# BRADLEY FAIR 2ND ADDITION TO WICHITA, SEDGWICK COUNTY, KANSAS

RE: S/D 95-78 - Revision to Final Plat of the BRADLEY FAIR 2ND ADDITION

RE: S/D 95-78 - Final Plat of the BRADLEY FAIR 2ND ADDITION

**CASE NUMBER:** S/D 95-78 BRADLEY FAIR 2ND ADDITION  
**OWNER/APPLICANT:** Wilson Estates, 200 Market Centre, 155 N. Market, WICHITA, KS 67206  
**SURVEYOR/ENGINEER:** Professional Engineering Consultants, c/o Rob Hartman, 303 S. Topeka, WICHITA, KS 67202  
**LOCATION:** South of 21st Street North and east of Rock Road  
**SITE SIZE:** 15.0 ± Acres

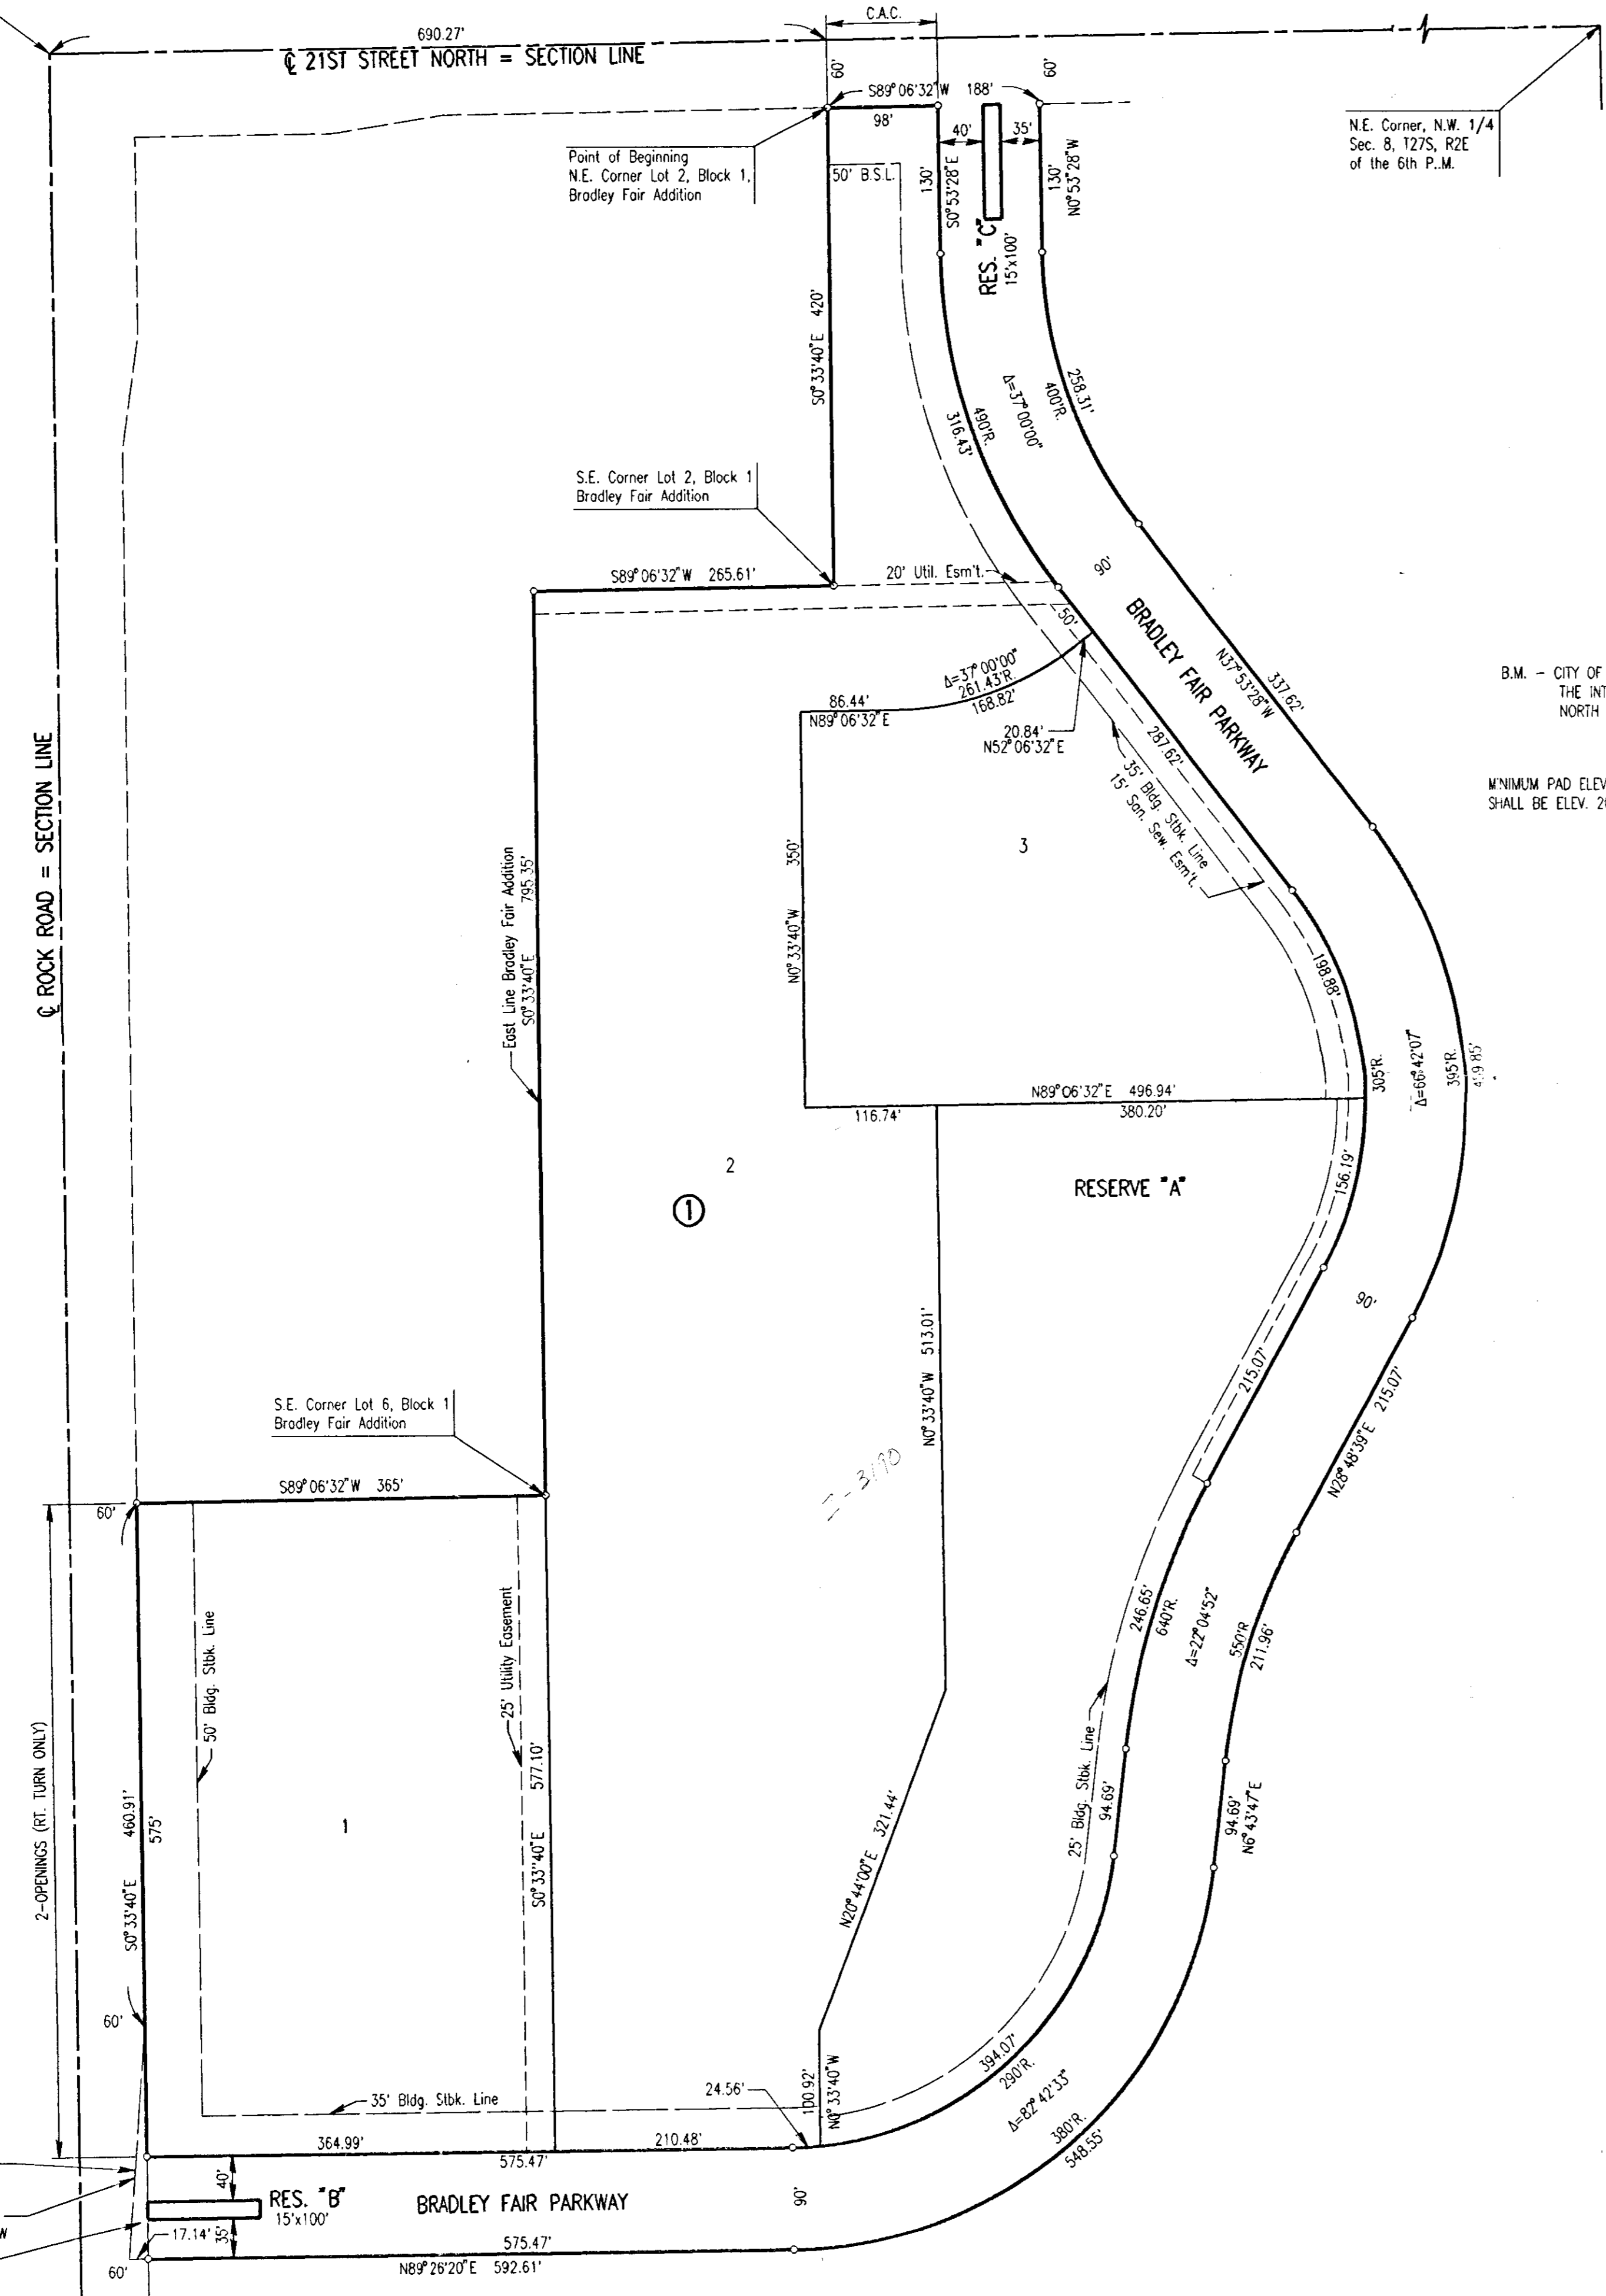
At the March 28, 1996 meeting of the Metropolitan Area Planning Commission (MAPC), your request to revise the above referenced plat was considered. The MAPC agreed that the Reserve area as originally platted within Bradley Fair Parkway's right-of-way could be revised as requested and shown on your revised plat. Except as necessary to reflect the above change, all conditions of approval as noted in the letter of January 18, 1996 are still in effect.

*3/25/96 - see revised copy of the final plat - MHA, IC approved & elimination of median / Reserve within Bradley Fair Parkway.*
